PLANNING COMMISSION REGULAR MEETING
Zoom Webinar and Town Council Chamber
3 S. Timber Ridge Parkway, Severance, CO 80550

AGENDA
PLANNING COMMISSION REGULAR MEETING
Wednesday, February 15, 2023, at 6:00 PM

5. Variance Request: BHS Solar UAR & Site Plan

6. Resolution PC-2023-01R: BHS Solar UAR & Site Plan

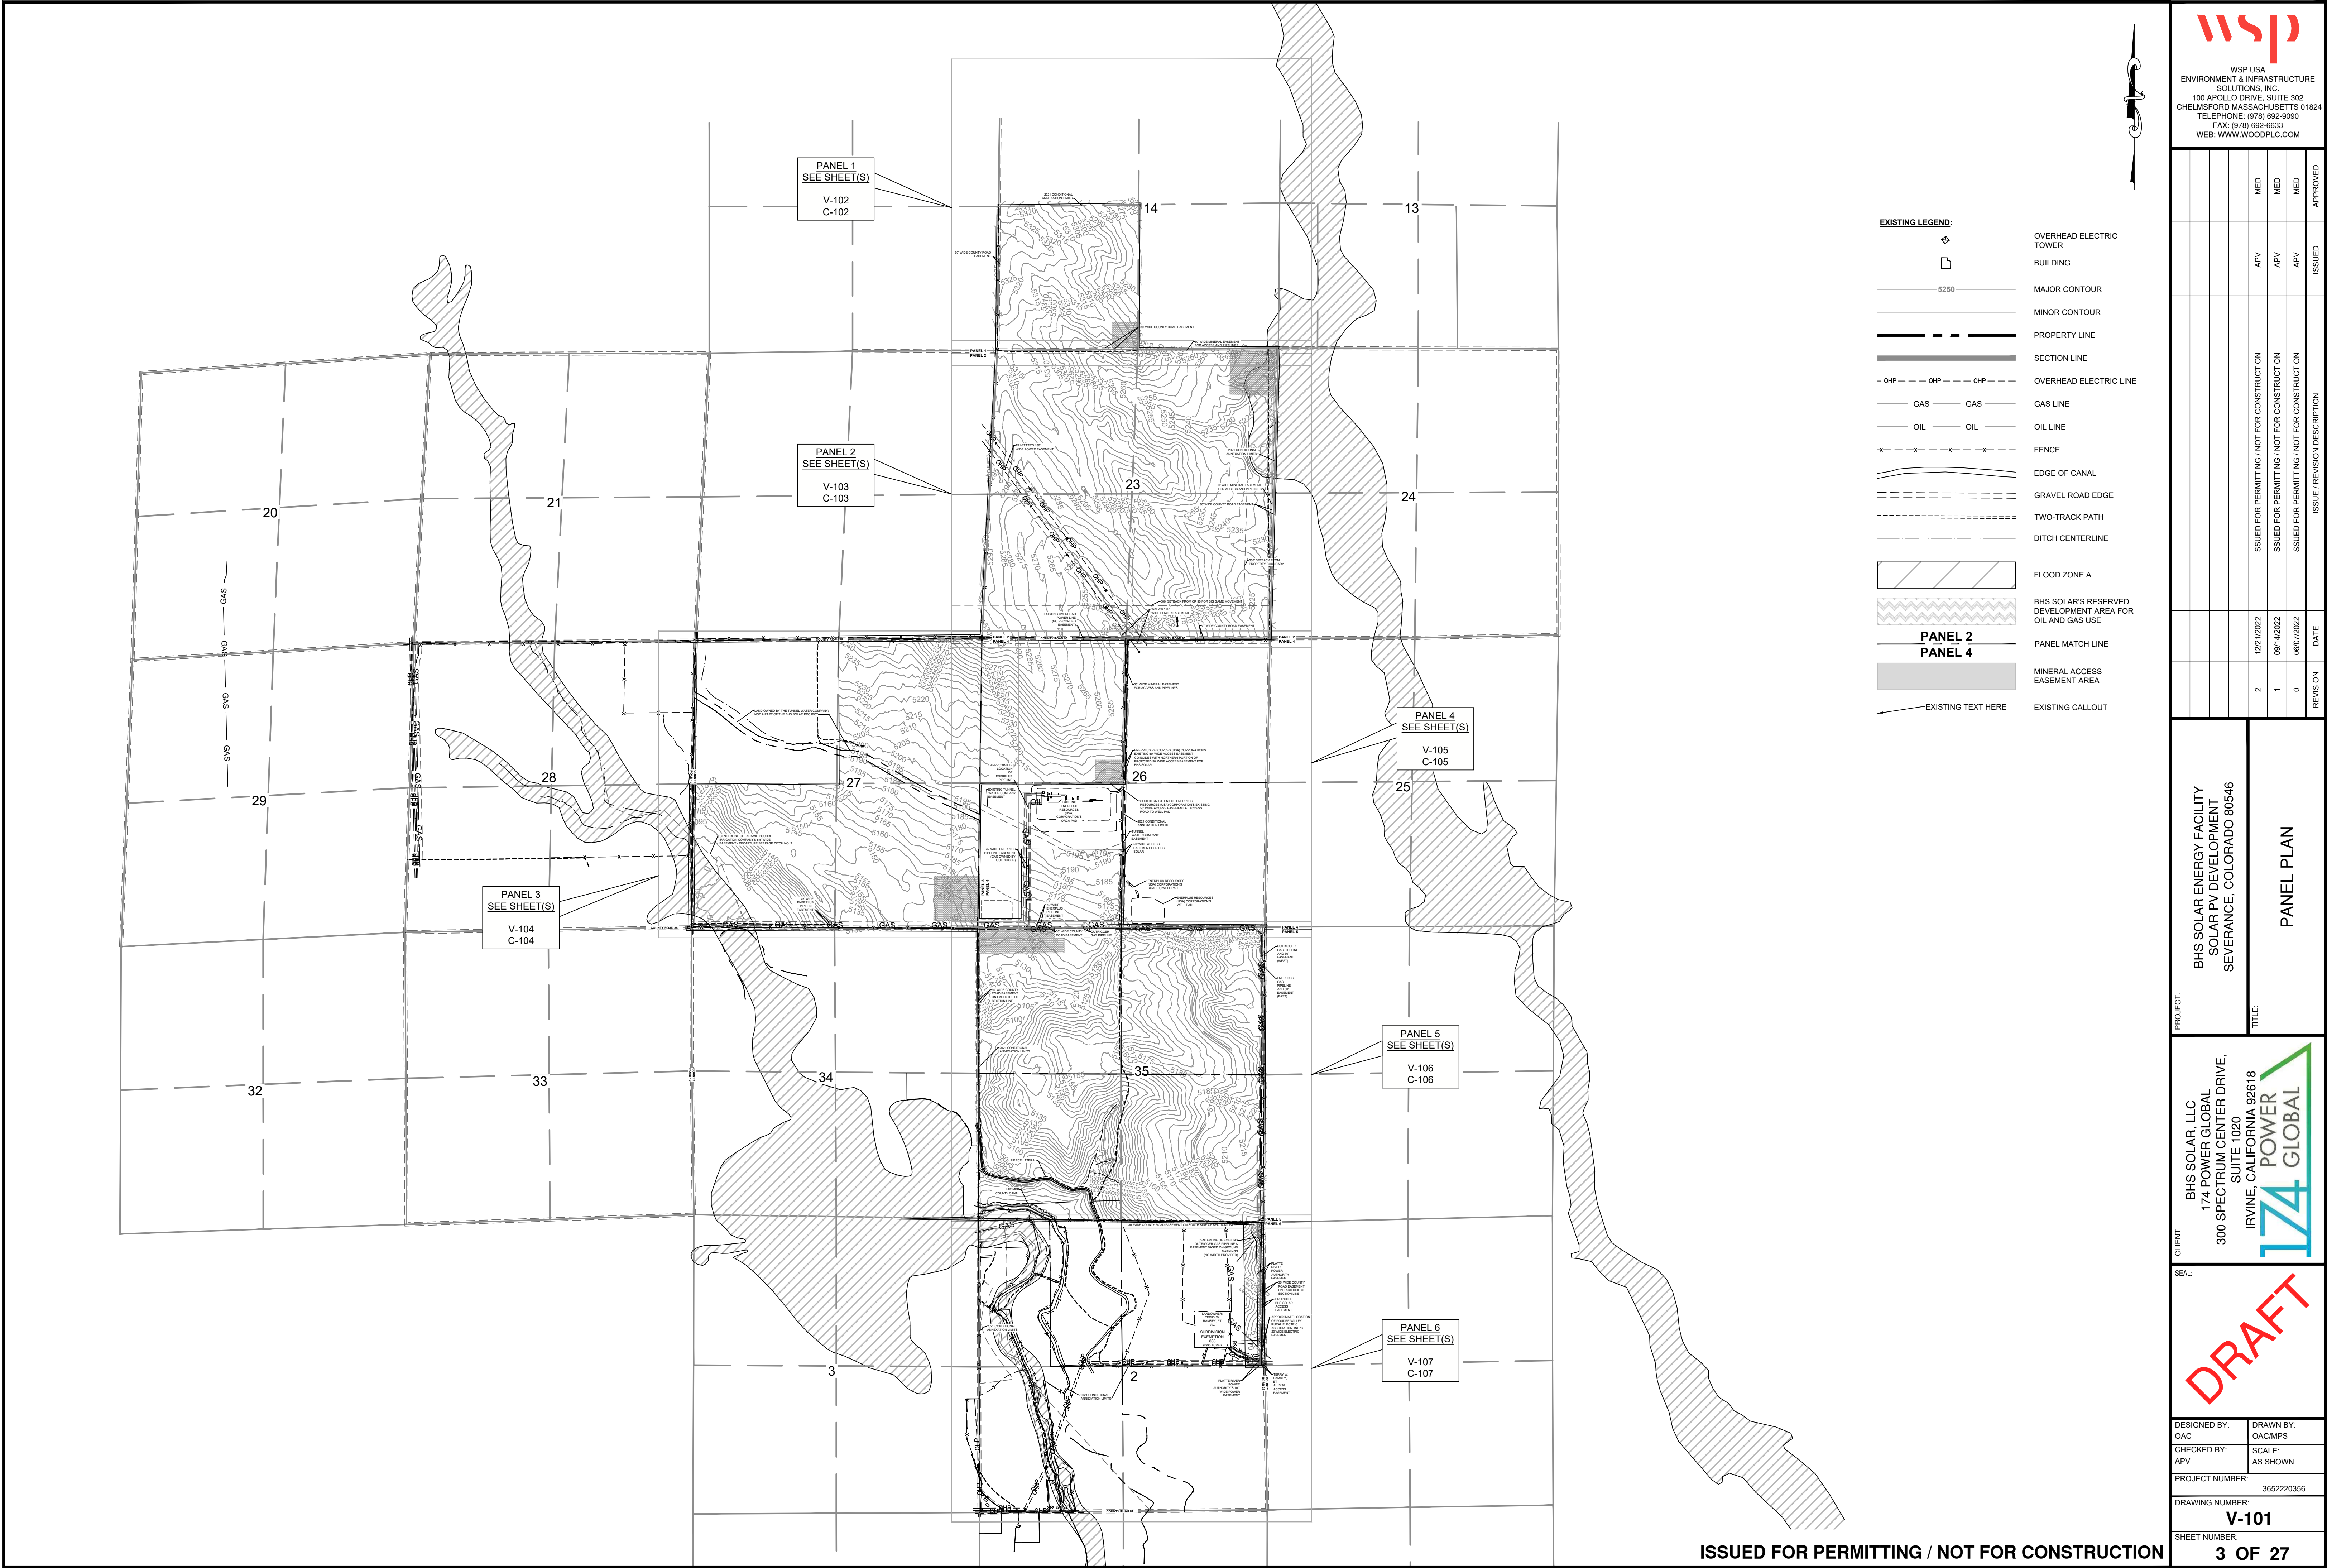
Item 1	Site Plan – Cover Sheet	Resolved? ☒ YES ☐ NO ☐ SEE ATTACHED
Notes	The signature blocks need to be on the cover sheet of the plan. Also, updated sheet numbering. The Cover Sheet is always Sheet 1 as it is part of the overall plan set. Update page numbers throughout.	
Applicant Response	Signature blocks added to cover sheet for Town and Land Owners.	
Notes	No further comment.	Resolved? ☒ YES ☐ NO ☐ SEE ATTACHED
Item 2	Site Plan – Cover Sheet	
Notes	Is there a reason for including both the vicinity map and the State map on the cover sheet? Vicinity map is most important for the community and site plan drawing set. In addition, the Vicinity map is barely legible at 100% zoom and not legible at

FIGURE 9

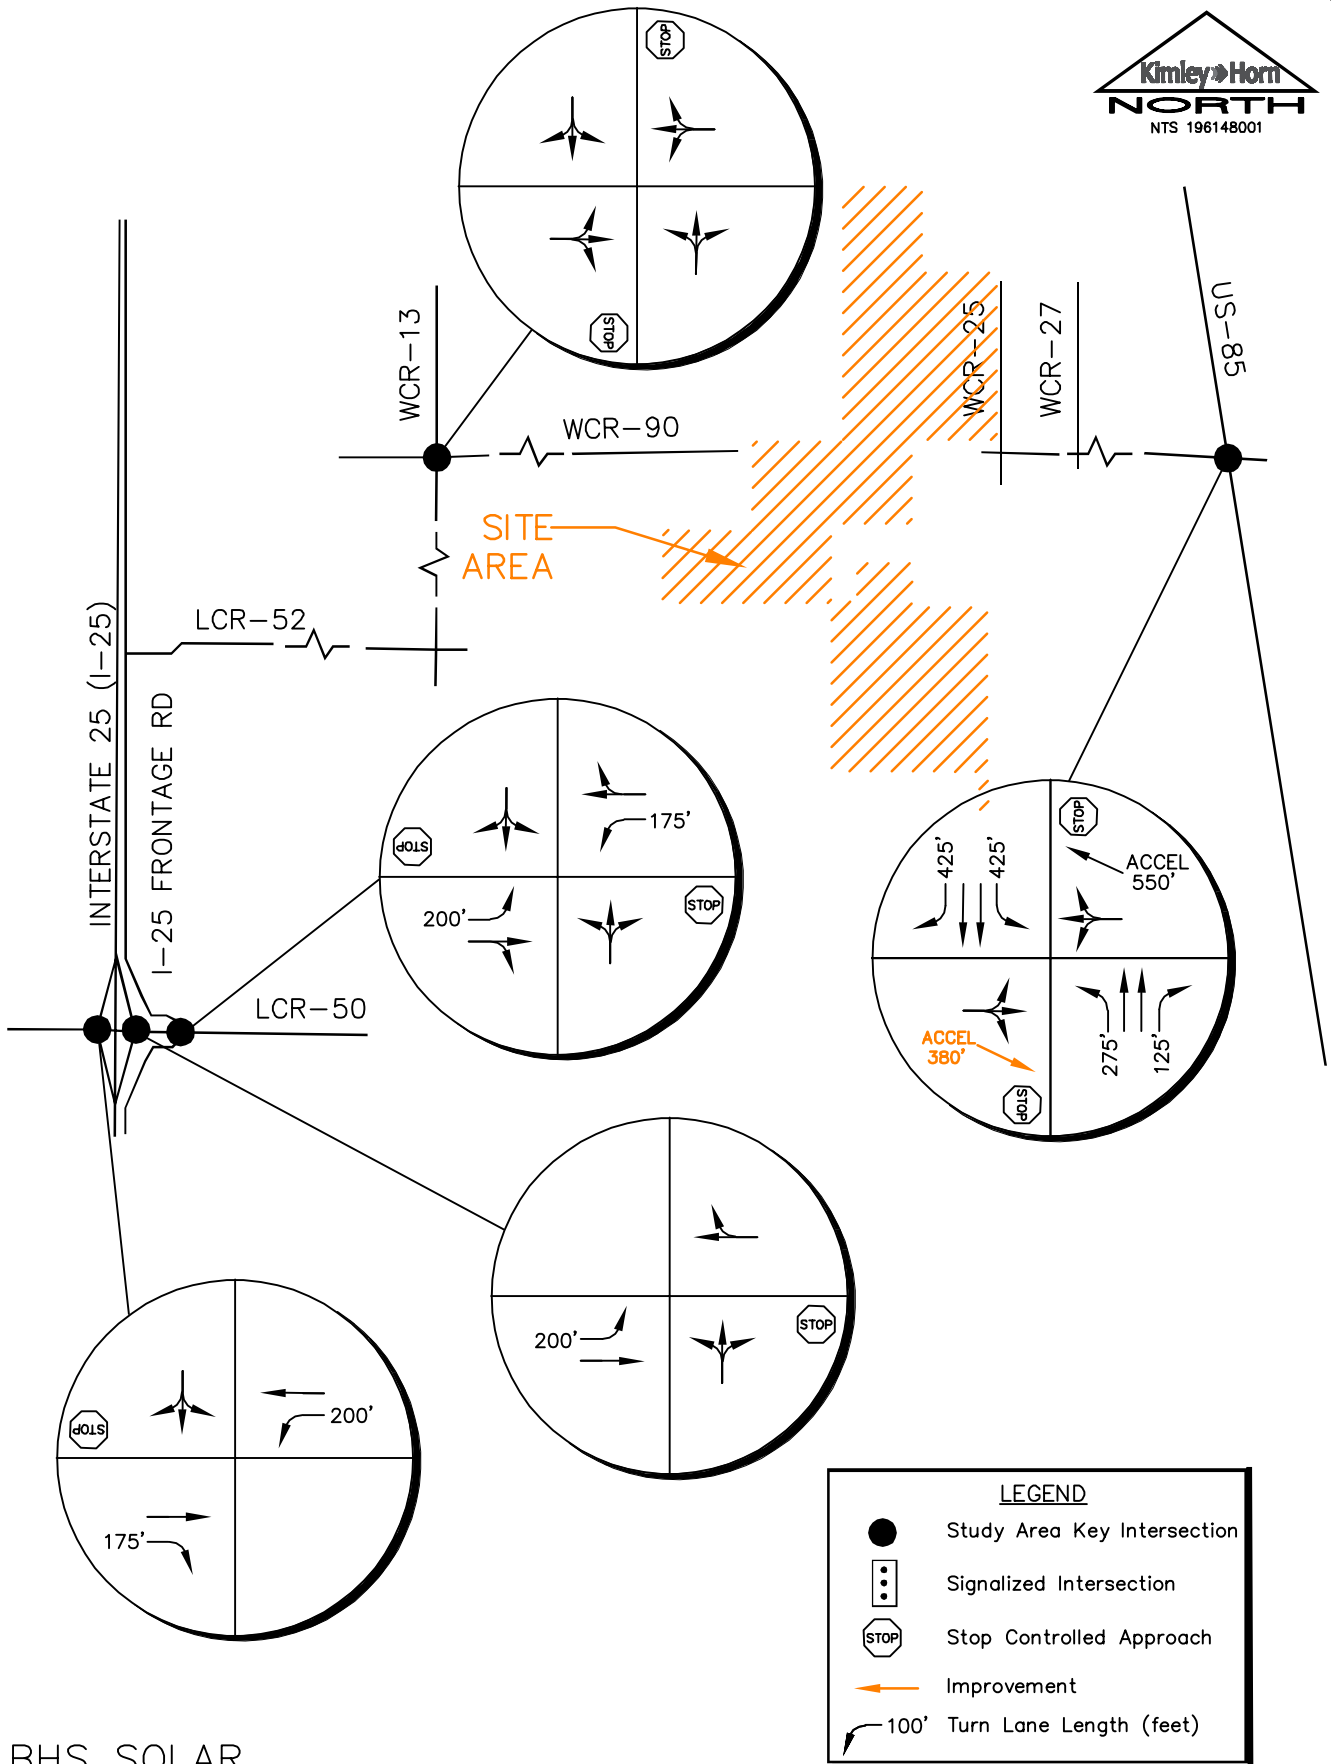
- b. Appears WCR90/Rowe in Pierce went from a haul route to a passenger vehicle route. Yet, it appears the exact same traffic volumes are projected to be used between the two traffic studies? For example, Figure 9 is the same. What facilitated the analysis of passenger vehicles using WCR90/Rowe as a focused route?
